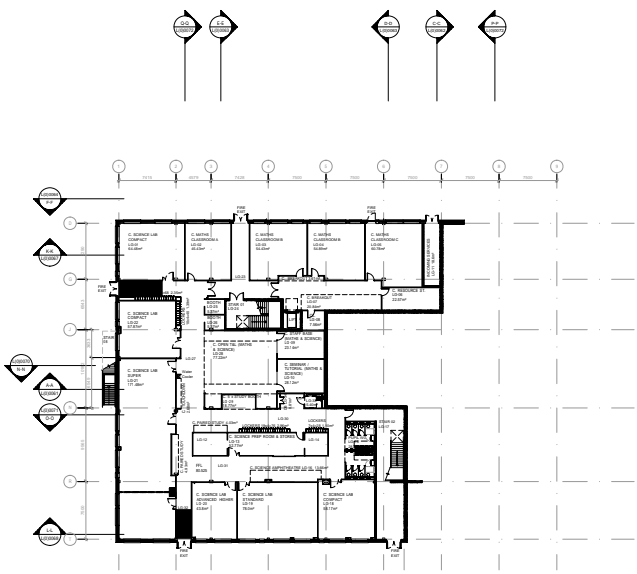
H	PARTITION BETWEEN LAB 105A & 105B MOVED TO MAKE CORRIDOR WIDER TO ALLOW FIRE EXIT TO BE A MINIMUM OF 1600MM. STAIRS EXIT DOOR CHANGED FROM SWING LEFT TO DOUBLE LEFT LOCKING MECHANISM FOLLOWING CONFIRMATION OF SIZE FROM FIRE SUPPLIER.	01.10.14	AA	G, B
D	ADDITIONAL COLUMN ADDED TO COL. BETWEEN LABS 105A AND 105B.	05.08.14	AA	G, B
F	2.5 x 1.00M BENCH UNIT ADDED TO SCIENCE SUPER LAB WITH 1000mm SPACE ABOVE. STATUS CHANGED TO CONSTRUCTION.	03.07.14	G, B	
E	INCISING SERVICES (S.G. 1) REDUCED IN SIZE FOLLOWING INSTRUCTION FROM CONTRACTOR. CHANGE REQUEST NOTES OMITTED.	11.06.14	G, B	
D	ROOM NUMBERING AMENDED & UPDATES TO DR. ARE. EXTERNAL WALL CONSTRUCTION CONFIRMED & UPDATES WINDOWS UPDATES. EXTERNAL WALL AND LINES & CONCRETE COLLARS REDUCED TO SUIT EXTERNAL WALL CONSTRUCTION. INCISING SERVICES (S.G. 1) REDUCED IN SIZE FOLLOWING INSTRUCTION FROM BCL. CHANGE REQUEST NOTES OMITTED.	30.04.14	G, B	AA
C	SCIENCE SUPER LAB (S.G. 2) - SLIDING PARTITION BUBBLED & CHANGE REQUEST TO BE MADE. REQUESTED CHANGE REQUEST NOTES KIBED.	20.02.14	G, B

B	ENTRANCE MATERIALS INDICATED. PURV. WC. S.G. 10 - WASH FOUNTAIN OMITTED & REPLACED WITH VENTY UNIT AS PER CLIENT INSTRUCTION.	08.11.13	G, B	RD
A	NOTES AMENDED. ROOM NUMBERING ADDED. STRUCTURAL GRID UPDATES & STRUCTURE ROOM NUMBERING AMENDED TO SUIT FROM DR. SERVICE RISERS & CDS INDICATED. INTERNAL WALLS UPDATES TO REFLECT ACCORDING TO BCL. INCISING SERVICES (S.G. 1) INCREASED IN SIZE TO MEET SERVICE REQUIREMENTS (AGREED WITH CONTRACTOR). STAIR BASE (S.G. 05, 06, 07, 08, 09, 10, 11, 12, 13, 14, 15, 16, 17, 18, 19, 20, 21, 22, 23, 24, 25, 26, 27, 28, 29, 30, 31, 32, 33, 34, 35, 36, 37, 38, 39, 40, 41, 42, 43, 44, 45, 46, 47, 48, 49, 50, 51, 52, 53, 54, 55, 56, 57, 58, 59, 60, 61, 62, 63, 64, 65, 66, 67, 68, 69, 70, 71, 72, 73, 74, 75, 76, 77, 78, 79, 80, 81, 82, 83, 84, 85, 86, 87, 88, 89, 90, 91, 92, 93, 94, 95, 96, 97, 98, 99, 100). SLEWING FOLDING PARTITION ADDED TO SCIENCE SUPER LAB (S.G. 21) FOLLOWING CLIENT INSTRUCTION. DEPARTMENT COLLOID OMITTED.	08.11.13	AA, SM	G, B
